City of Poughkeepsie
Planning Board
Meeting Agenda

Common Council Chambers
Wednesday, June 21, 2023
6:00 PM

1. 36 NORTH Clover, Pelton Manor – Site Plan
Application for Site Plan Amendment review regarding establishment of 46 residential units and related parking and amenities. Owner/Applicant: Pelton Partners, LLC; Consultant: LRC Group; Grid #6062-75-837228 Zoning District: R-4 (Medium-High Density Residential); File #PB2023-044

DRAWING No.
A100

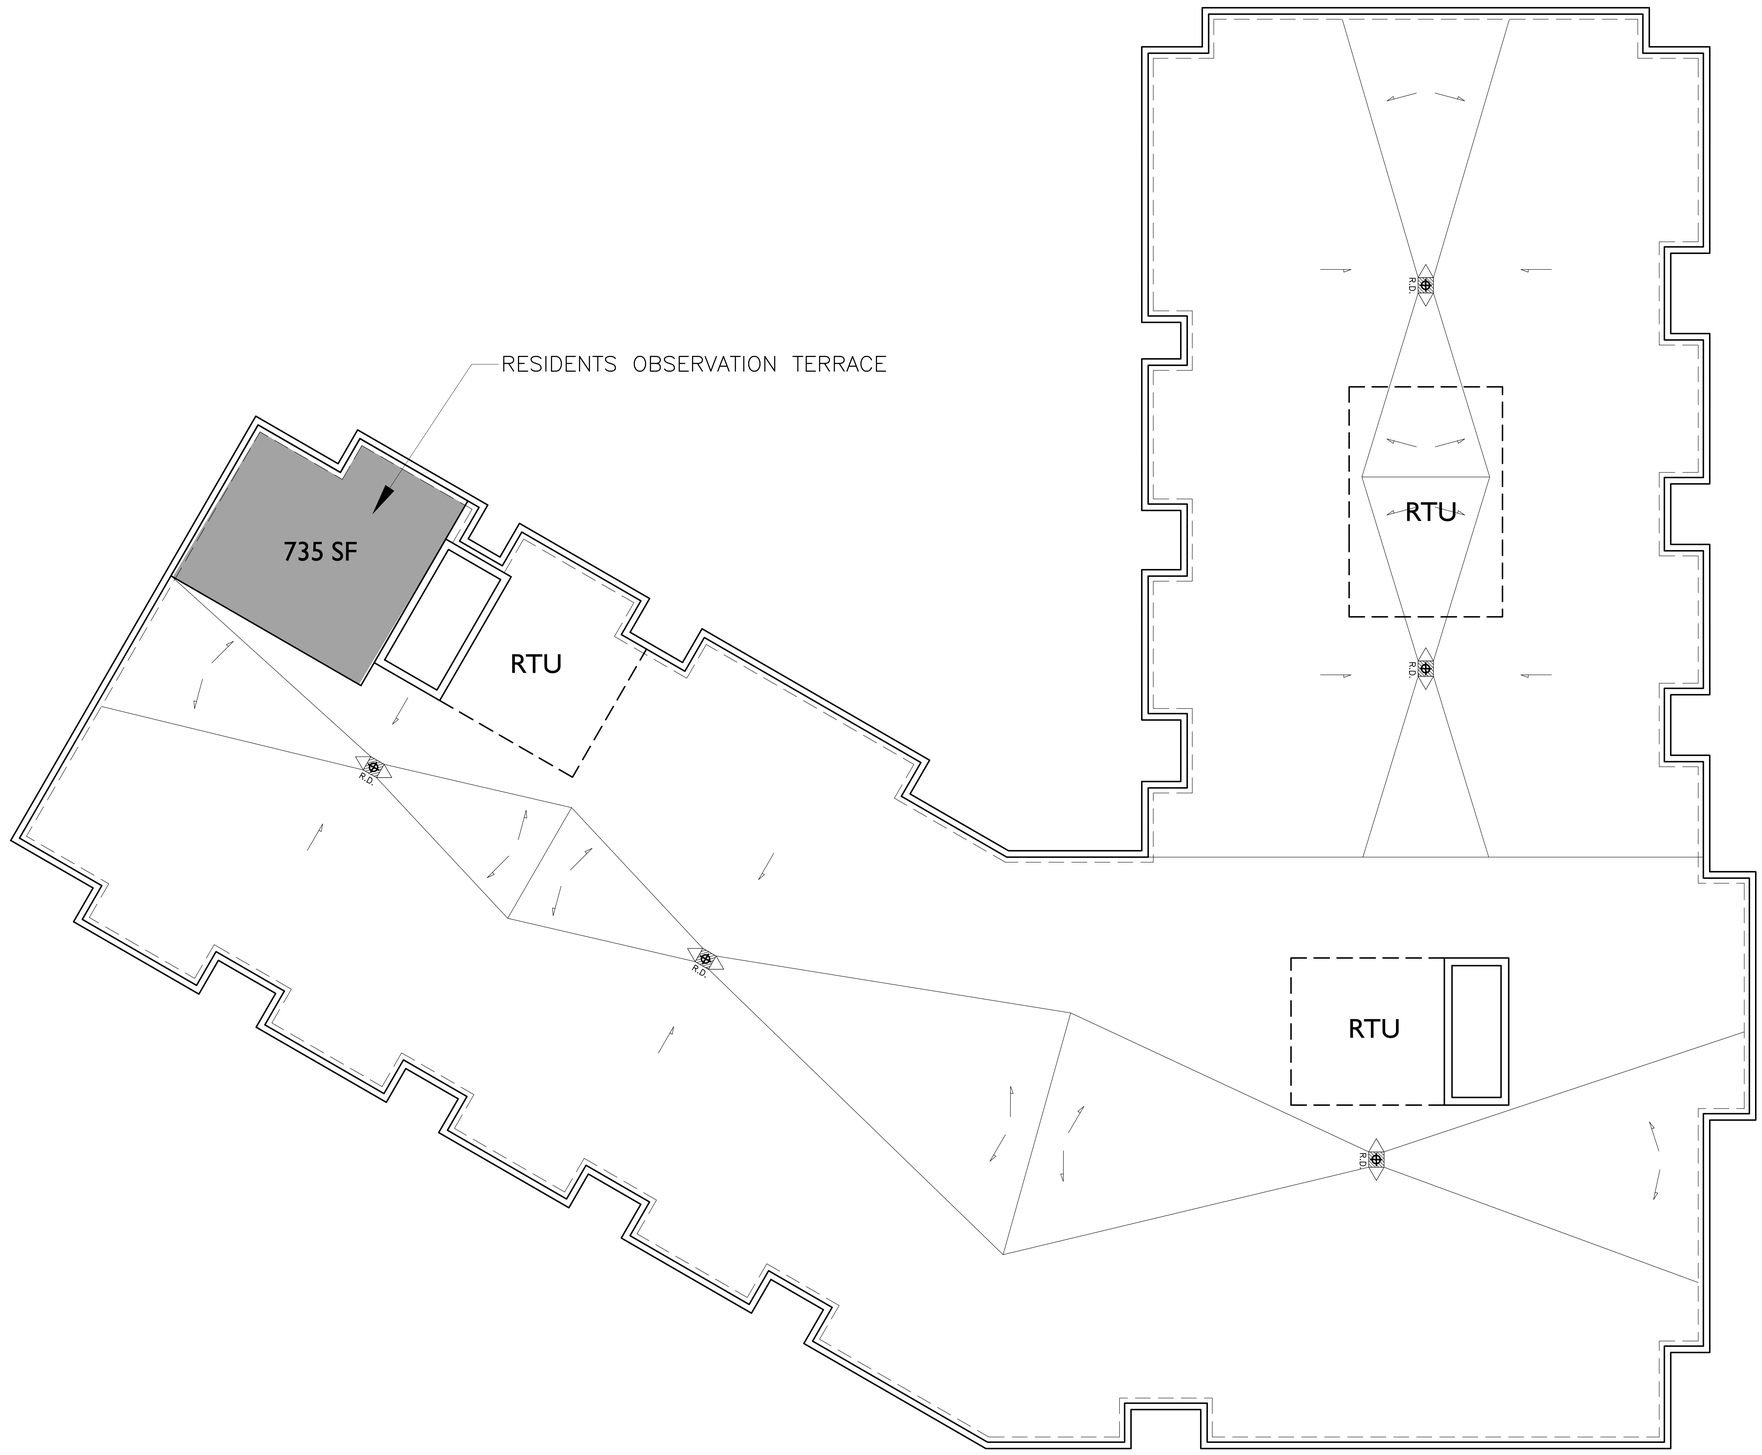
Response: The four accessible spaces on Sheet C120 are now 9-ft in width. See revised Architectural drawing A100. Parking spaces within the garage have been modified to 20 feet long with a 22-foot wide aisle as shown on LMV parking plan.

C195

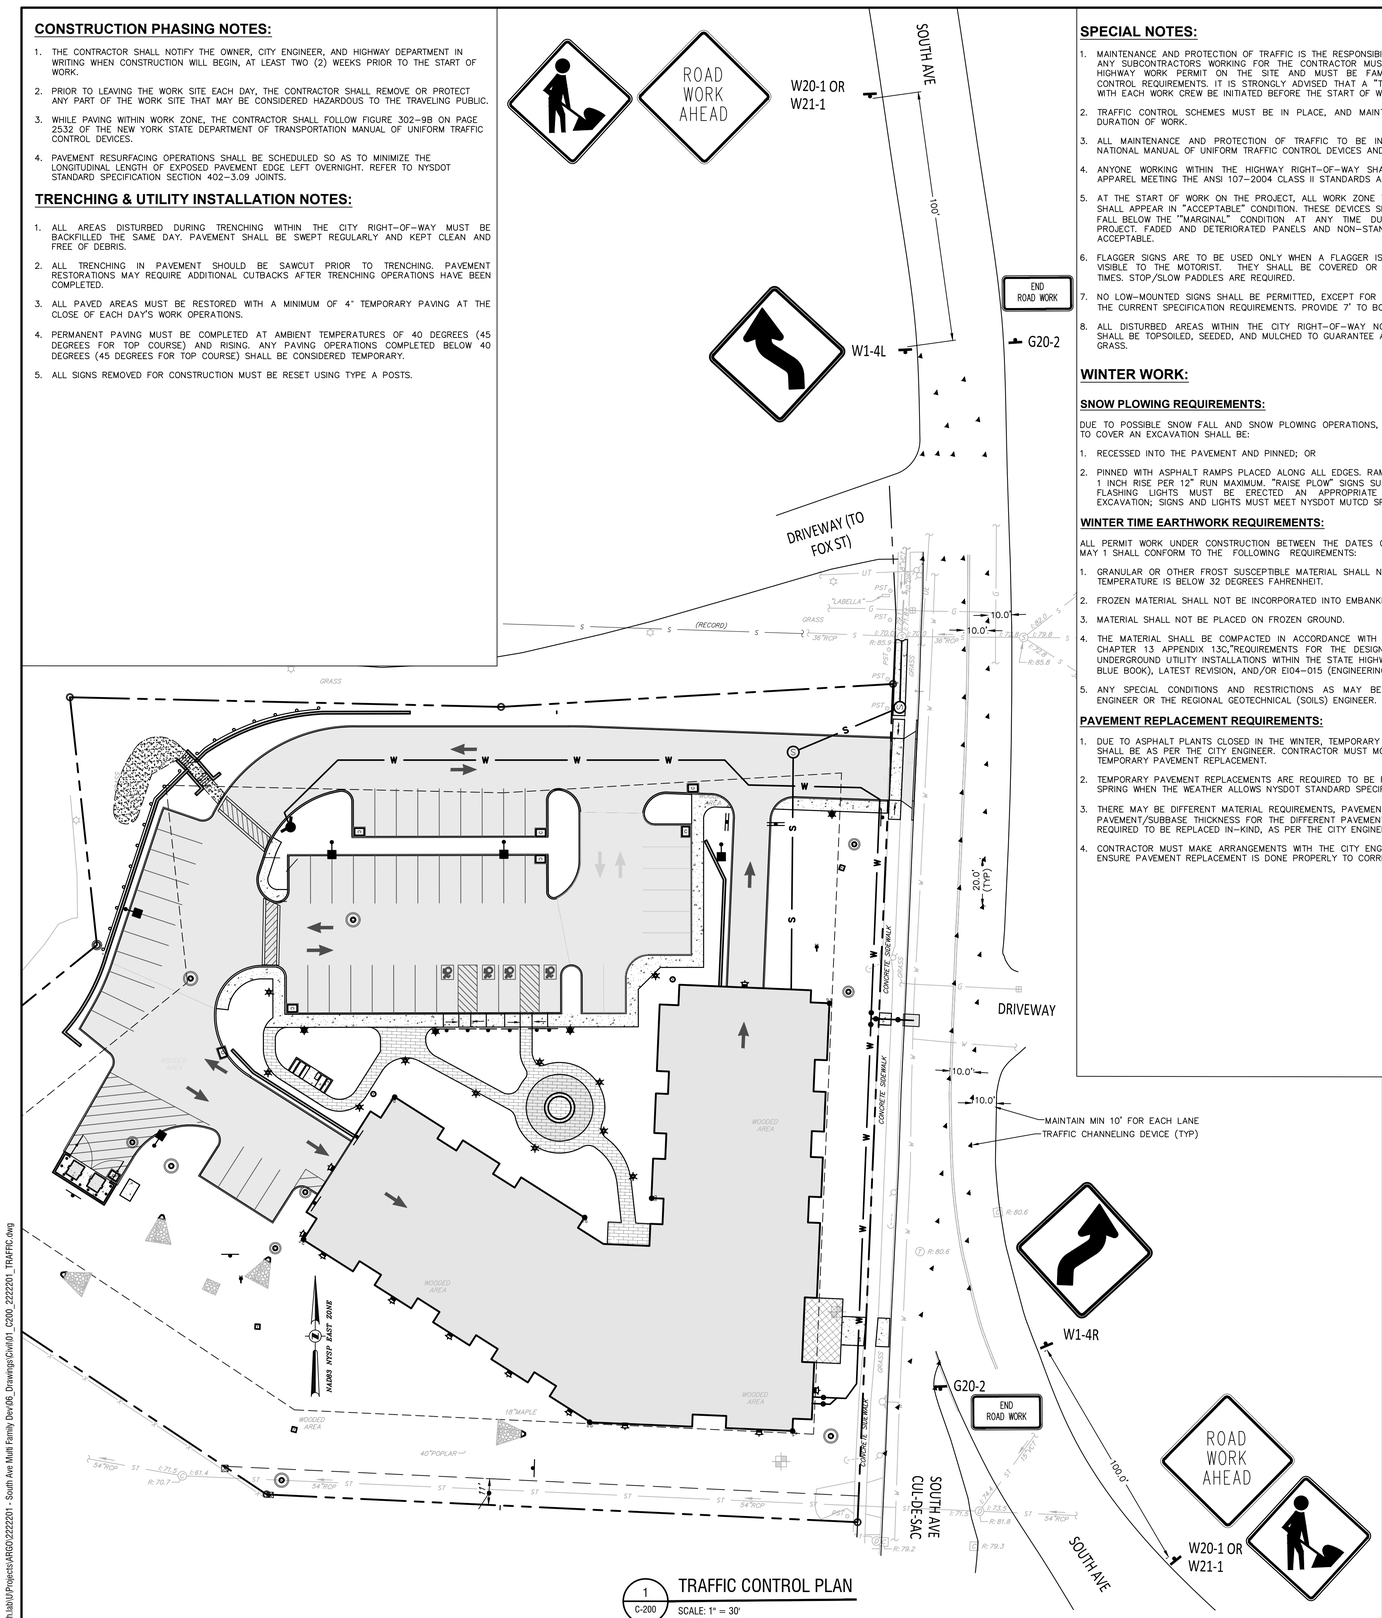
Response: Total open space area of 44,843 sf has been shown on Sheet C195.
